YARRA CITY COUNCIL
Internal Development Approvals Committee
Agenda

**to be held on Wednesday 17 January 2018 at 6.30pm
in Meeting Rooms 1 & 2
at the Richmond Town Hall**

Item		Page	Rec. Page
1.1	PLN17/0456 – 594-612 Church Street, Cremorne - The construction of an eight storey building plus three basement levels and a roof top terrace, the use of the land for a shop, a reduction in the car parking requirement associated with office and shop, a waiver of the loading bay requirement and alterations to the access to a road in a Road Zone, Category 1 by removing the crossover to Church Street.	5	35

1. This report provides Council with an assessment of planning permit application PLN17/0456 and recommends approval subject to conditions.

Advertised/decision plans

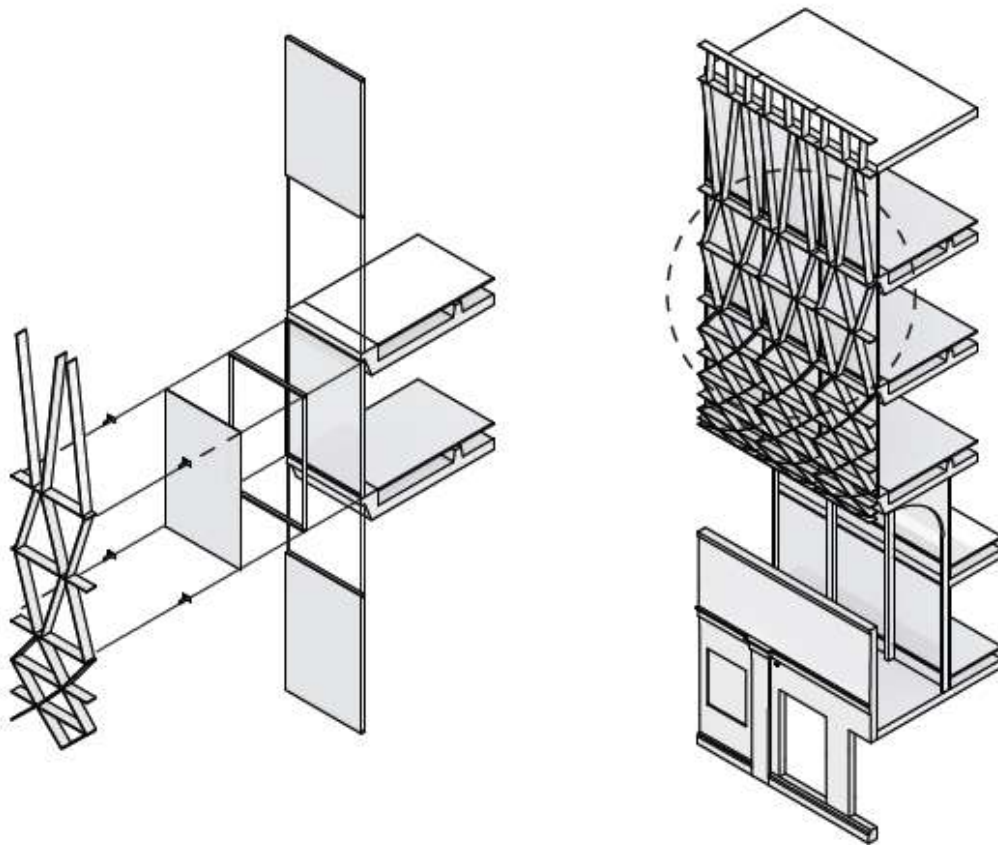
- (iii) *The rebate and 7 metre setback are acceptable but I would like them to improve it along the lines of making the soffit less visually imposing – softening it somehow, creating less of a shadow line.*
- (iv) *The shadow underneath makes it look heavy in daylight whereas at night the illumination is fine. Maybe 24 hour illumination?*
- (v) *Height and texture are acceptable.*

95. The proposal would be the same overall height and the result is a form that adopts a complementary geometry to the base. While the general form would now respect the host or base building, with the upper level setbacks reduced (due to the loss of the curve), the upper levels would now be dominant when viewed along Balmain Street. While the 300mm western setback could be tolerated across levels 3-5 (previously 550mm-1.9m), this is due to the approval of the site to the north and because Stephenson Street is a secondary street. However, the 300mm setback from the southern boundary (previously 4.5m to 6.7m) is not supported as the upper level would appear too dominant above the heritage base and also generally from an urban design perspective when looking east down Balmain Street.

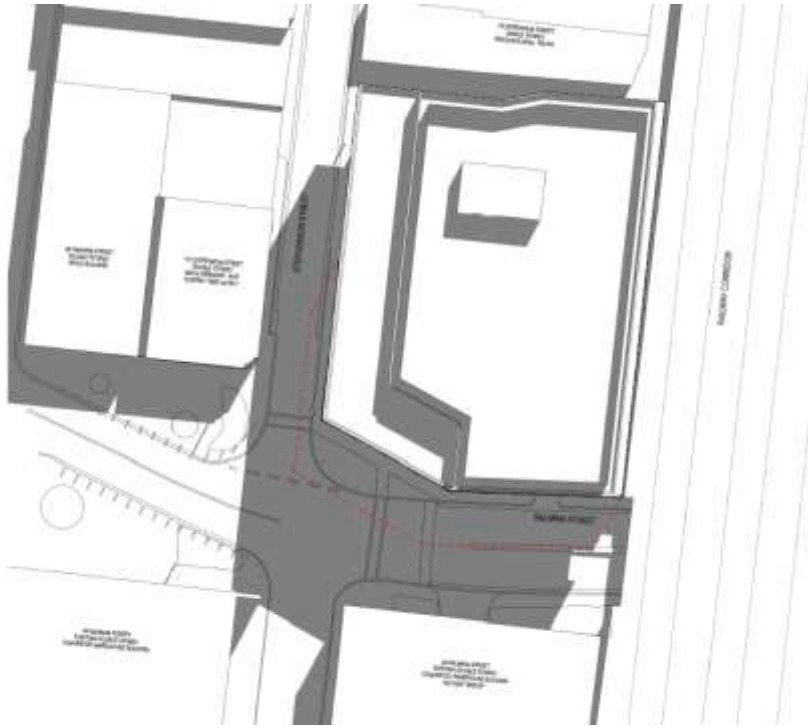
106. Council's Heritage Advisor also supported the restoration of the Rosella signage on the parapet.

107. Council's Heritage Advisor also indicated that there may have previously been a Rosella sign on the eastern façade of the building. The Applicant's heritage report confirms this. While the Heritage Advisor requested this sign be reinstated, the wall would be demolished as part of this application and replaced with a crash wall (due to its positioning next to the railway line). The reinstatement of the sign will therefore not be required (noting the sign has not been visible for some time due to the graffiti). On balance and due to the reinstatement of the other signs, the application is still considered to result in a net improvement to the heritage fabric.

Demolition

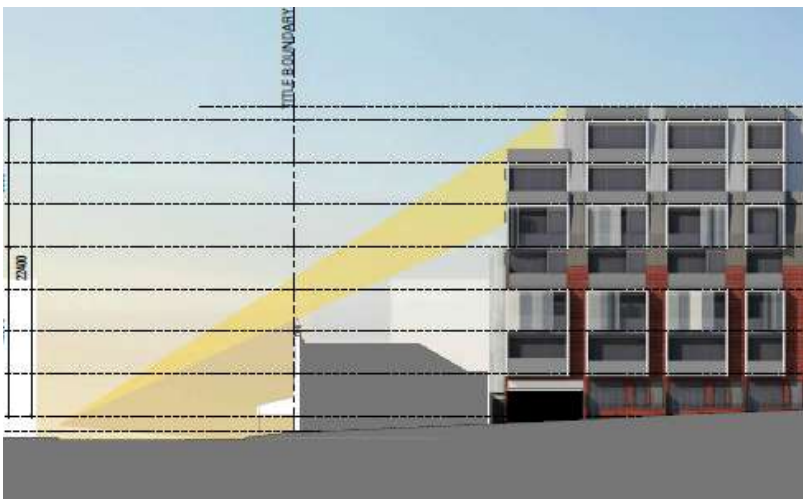
128. The advertised application proposes part demolition of the Bridge Road facade to allow site access during construction. This would also include the removal of the glazing and the verandah with retention of the perimeter walls and parapet. At completion of construction, the façade and the verandah would be reconstructed like for like. Council's heritage advisor has not raised concern with the sections of the building to be removed during construction. It was noted that these elements are not original to the building and therefore their removal and subsequent reconstruction would not be detrimental to the integrity of the heritage place. However, the extent of demolition compromises the stability of the remaining sections of the façade that are original and of greater heritage contribution to the heritage streetscape. Of particular concern is associated with the loss of the raised parapet and moulding detailing within the façade.

129. Structural design advice prepared by WSP Structures was submitted by the applicant, detailing the construction methodology including identification of the load bearing walls and new strengthening works required to stabilise the retained portion of the facade during the construction process. Given the risks associated with the potential collapse of the façade, the construction methodology was discussed with Council's Building Services and Construction Management Units. Council's Construction Management Unit was not satisfied that the proposed temporary openings within the façade would be sufficient to facilitate the construction of the building. The applicant has advised that an alternative construction methodology is now being explored that does not involve demolition to the front façade. The alternative construction process would be confirmed via a construction management plan required as a condition of any permit that issues. No further detail is necessary at this stage for the purposes of assessing the current application. Amended Plans will also be required if a permit is issued showing the full retention of the Bridge Road façade.

Micro Climate impacts

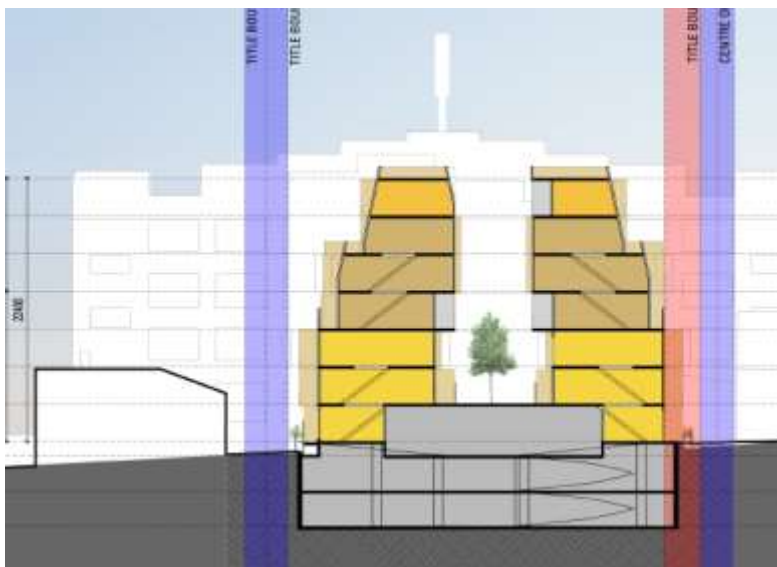
167. A wind tunnel assessment has been undertaken by MEL Consulting dated July 2017. This confirmed that the wind conditions in the streetscapes surrounding the proposed development and the central landscape area are either within or on the criterion for walking comfort for all wind directions, with many achieving the criteria for stationary activities. This is considered satisfactory.

Daylight to existing windows

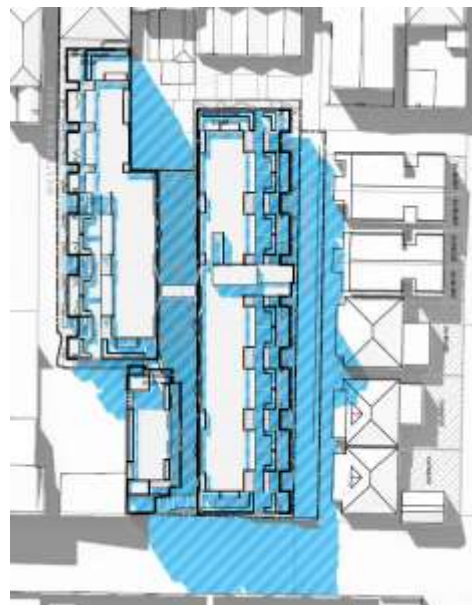
174. It is understood that all windows facing Allowah Terrace are associated with bedrooms. While the proposed development may reduce the level of daylight to these rooms, this impact would be acceptable. Specifically, daylight to bedrooms is not as critical for amenity as main living spaces given their primary purpose for sleeping. The proposed development would not compromise the daylight access into the main living spaces of these dwellings and therefore an acceptable level of amenity will be maintained.

Overshadowing

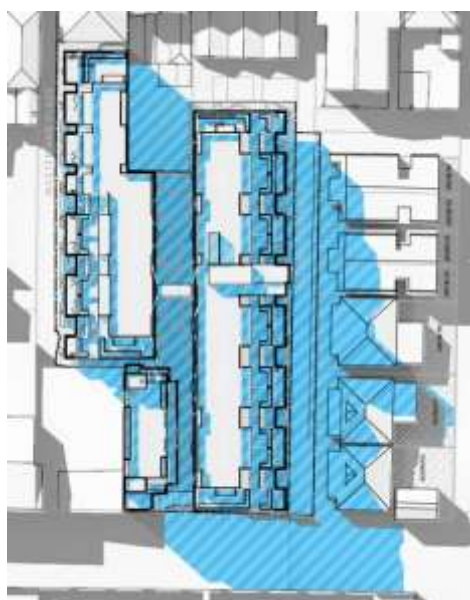
175. Shadow diagrams have been prepared for the September Equinox between 9am and 3pm, reflective of the information provided to assess Clause 55, Overshadowing Standard B21 (see below). This illustrates that there will be no additional shadow cast upon the secluded private open space areas of the properties along the eastern side of Allowah Terrace between 9am and 2pm. There is an increase in overshadowing to No. 4 Allowah Terrace at 3pm of approximately 10 per cent, however it is noted that approximately 65-70% of this area is already in shadow at 3pm. On this basis, the increase of shadow is not considered to result in unreasonable amenity impacts. No other secluded private open space areas will be further impacted at 3pm. Objections have been received raising concern with overshadowing within the front setback areas, however as these areas are not secluded, nor are they the only open space areas for these dwellings, the increased overshadowing in the afternoon is not unreasonable. This would also have been the case if these dwellings were in a residential zone.
